POINT BEACH - UNITS 1 AND 2  
 TECHNICAL SPECIFICATION CHANGE REQUEST NO. 87  
SUMMARY OF CHANGES

POINT BEACH NUCLEAR PLANT, UNITS 1 AND 2  
TECHNICAL SPECIFICATION CHANGE REQUEST NO. 87

REVISED PAGES

Figure 15.2.1-1

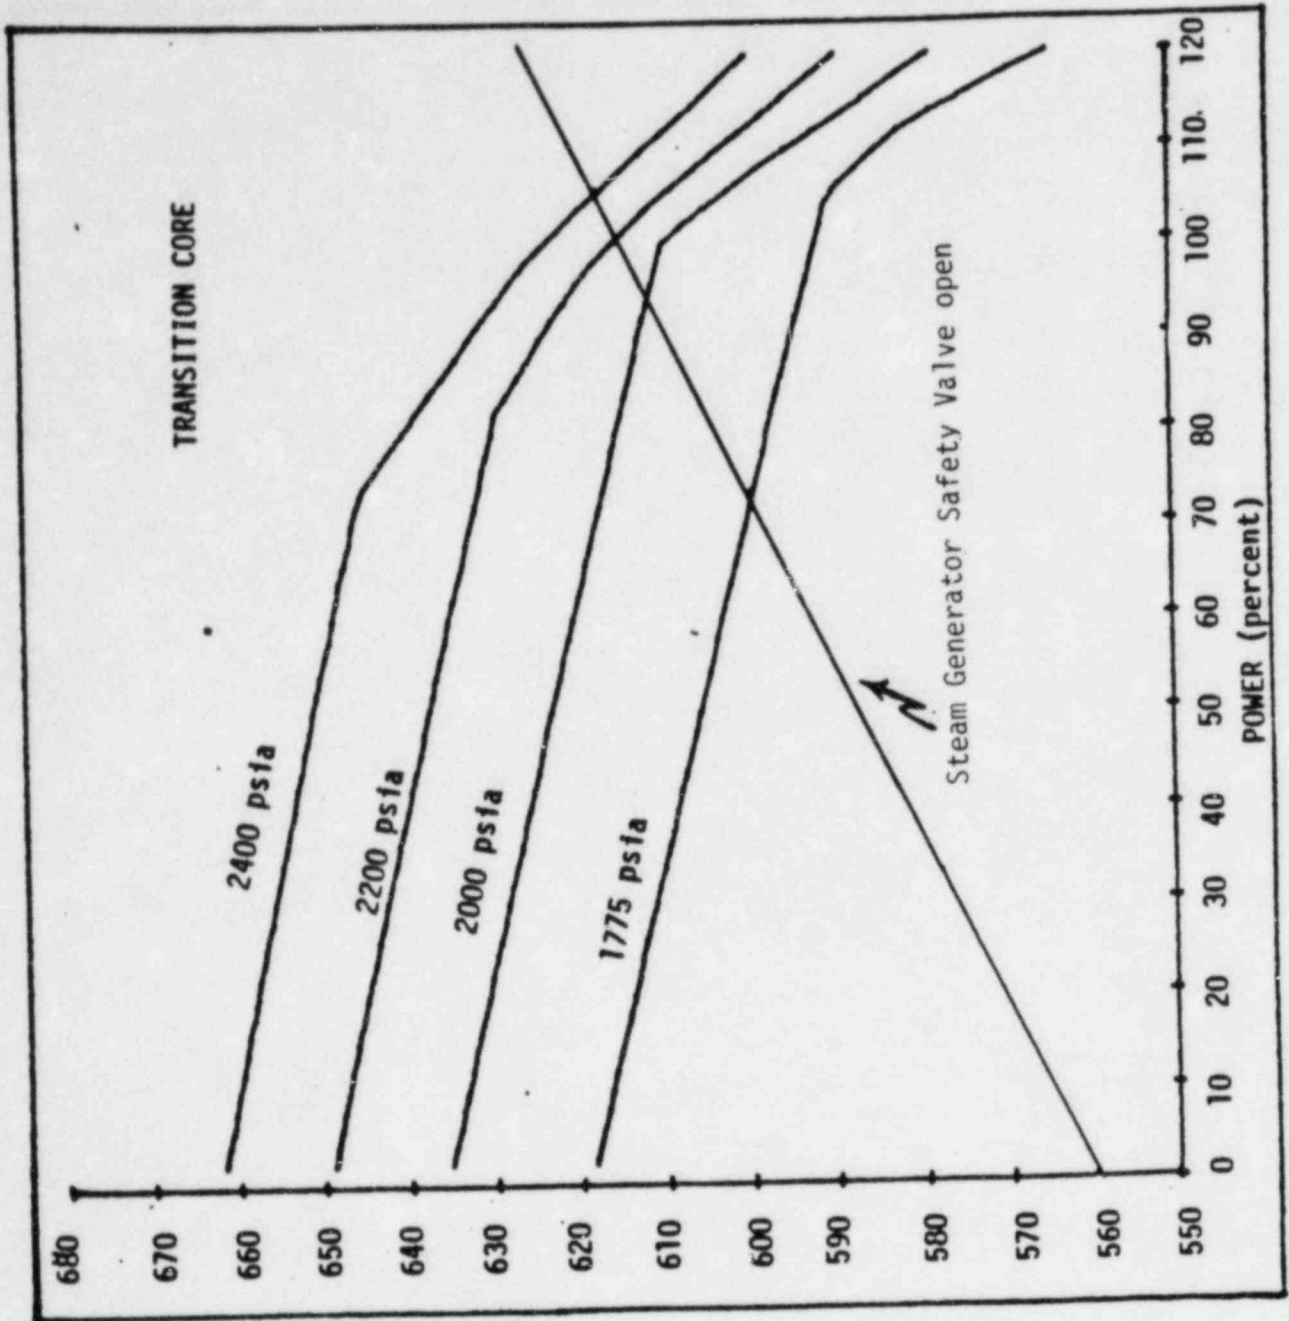
15.2.1-1	15.2.1 Specification 1., line 3, change "Figure 15.2.1-1" to "Figure 15.2.1-1 for a transition core* and Figure 15.2.1-2 for the full optimized fuel assembly (OFA) core." Add to the bottom of page: "*Transition core is defined as being any core loading pattern consisting of standard and optimized 14 x14 fuel assemblies, not including OFA demonstration assemblies.	As a result of conversion to OFA, two safety limit figures are presented, one for transition cores and one for full OFA cores.

15.2.1-2 and 15.2.1-3	The basis has been rewritten to address both transition and full OFA cores. Discussion of DNB correlations and the $.3 F_{\Delta H}$ multiplier is included. Figures 15.2.1-1 and Figures 15.2.1-2 were revised to reflect the safety limits with optimized fuel applicable to both Units 1 and 2.	The basis has been rewritten to reflect a more current Technical Specifications (tech spec) description on this subject. As a result the tech spec has been simplified and abbreviated.

The curves of Figure 15.2.1-1 are applicable to transition cores. The W-3 correlation is used to generate these curves. The DNBR limit of this correlation is shown to be met in plant safety analyses using values of input parameters with uncertainties considered at fixed conservative values.

FIGURE 15.3.10-3  
POINT BEACH UNITS 1 & 2  
HOT CHANNEL FACTOR NORMALIZED OPERATING ENVELOPE

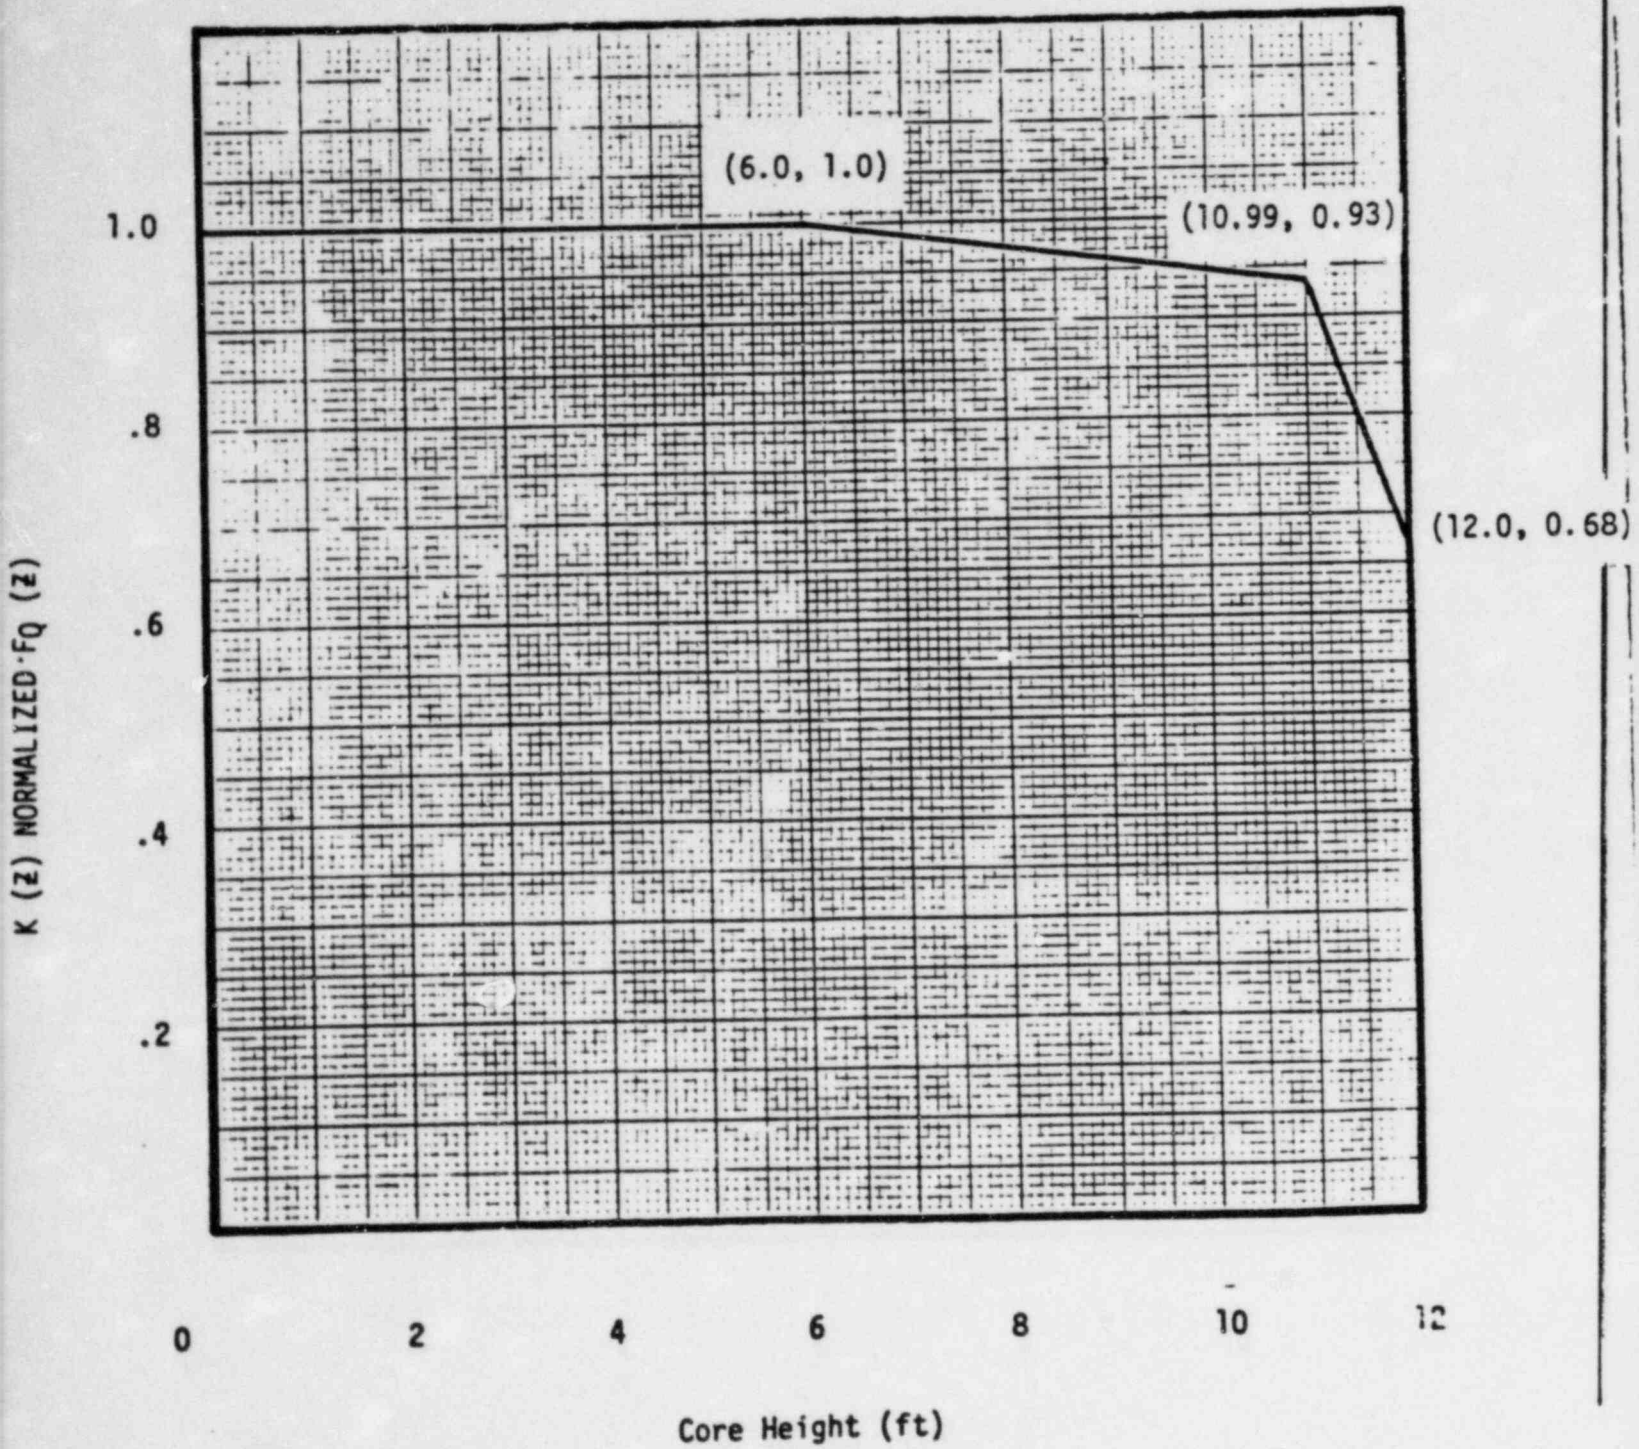
<u>Page</u>	<u>Description of Specification Change</u>	<u>Comments</u>
15.3.10-12 thru 15.3.10-13	The basis for Axial Power Distribution was completely rewritten to incorporate RAOC. The $\Delta I$ envelope constructed assures that the LOCA $F_Q$ limit is not violated during normal operation.	The tech spec wording is consistent with that employed in the RAOC generic report submitted to the NRC. It should be noted that the RAOC analysis methodology described in the report is consistent with the methodology utilized for Point Beach.
Figure 15.3.10-1	The control rod insertion limits were changed slightly, as a contingency measure.	Variations in fuel management, such as abnormally short or long cycles could necessitate future revisions to the $\Delta I$ operating envelope. Raising the insertion limits slightly will make a revision less likely. This change is not necessary for optimized fuel.
Figure 15.3.10-3	The LOCA K(Z) curve was revised.	Resulted from optimized fuel LOCA analysis.

FIGURE 15.3.10-4  
FLUX DIFFERENCE  
OPERATING ENVELOPE  
POINT BEACH UNITS 1 & 2

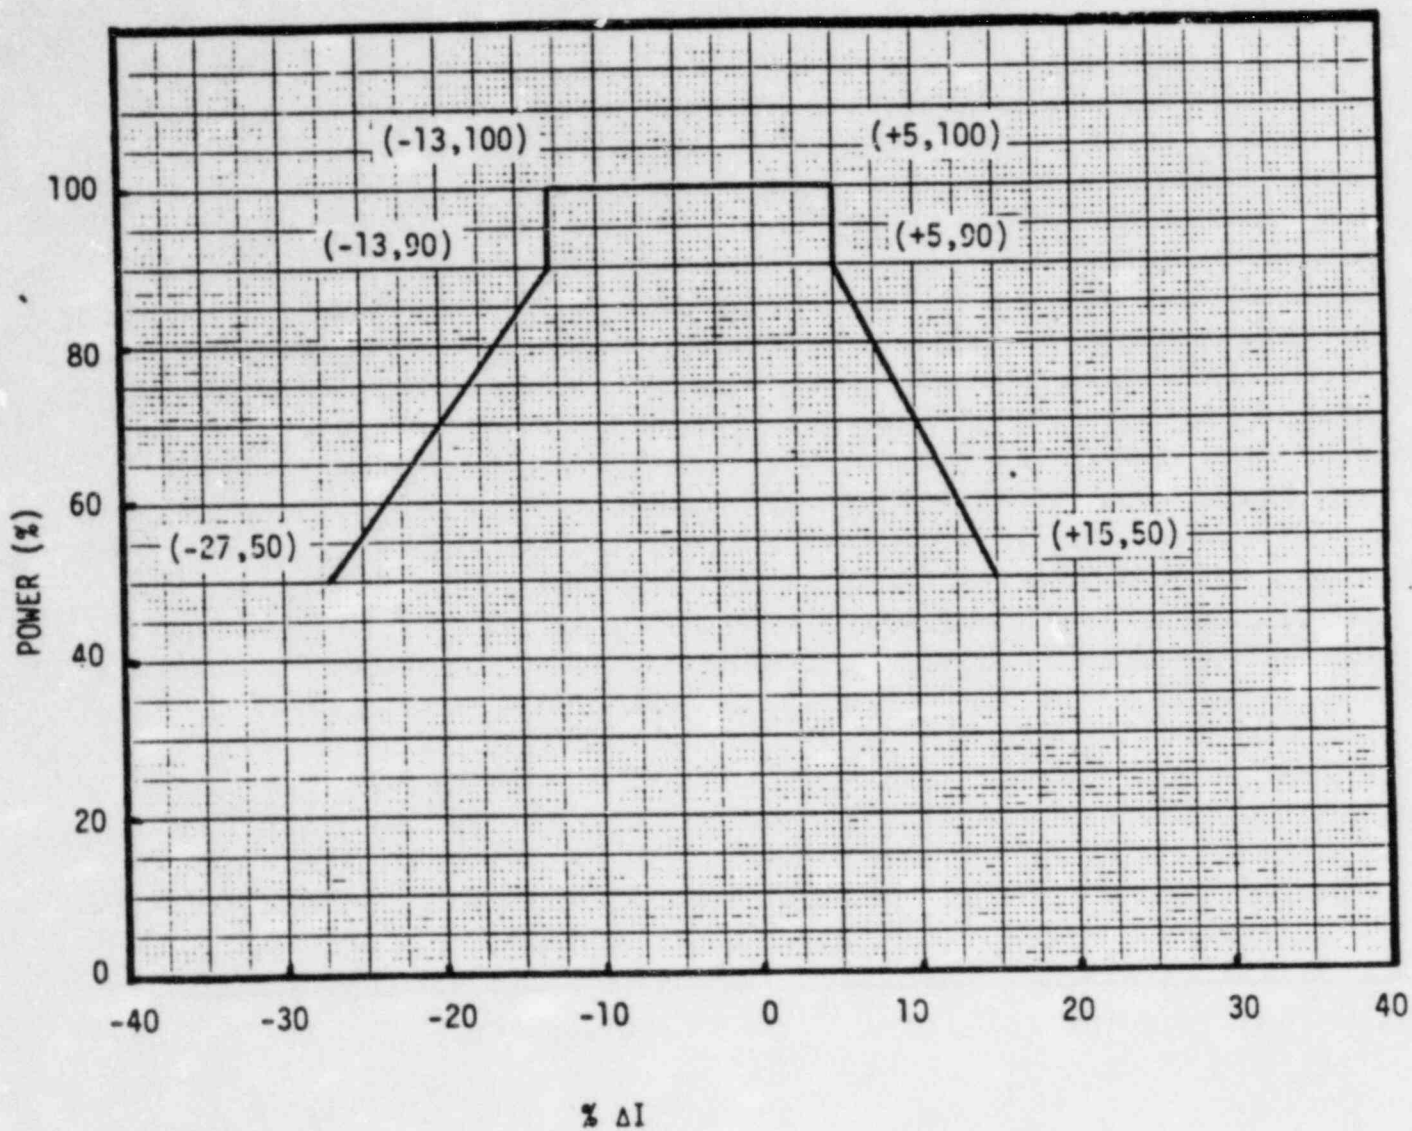
Figure 15.3.10-4	Flux difference operating envelope.	Required for RAOC.
Table 15.4.1-1	1. Nuclear Power Range under "check" monthly add "(4)" and under "Remarks" add "(4) Compare incore....3 percent."	Clarification of incore/excore calibration to within 3 percent. Credit was taken for this requirement in OP and OT $\Delta$ T Setpoint.

2. a. The indicated axial flux difference (AFD) shall be maintained within the allowed operational space defined by Figure 15.3.10-4 except during physics tests. The physics test exemption applies provided that the thermal power is less than or equal to 85% of rated thermal power and the limits of specification 15.3.10.B.1.a are satisfied. During suspension of the specification, the thermal power shall be determined to be less than or equal to 85% of rated thermal power at least once per hour. In addition, the surveillance requirements of 15.3.10.B.1.b shall be performed at least once per 12 hours.
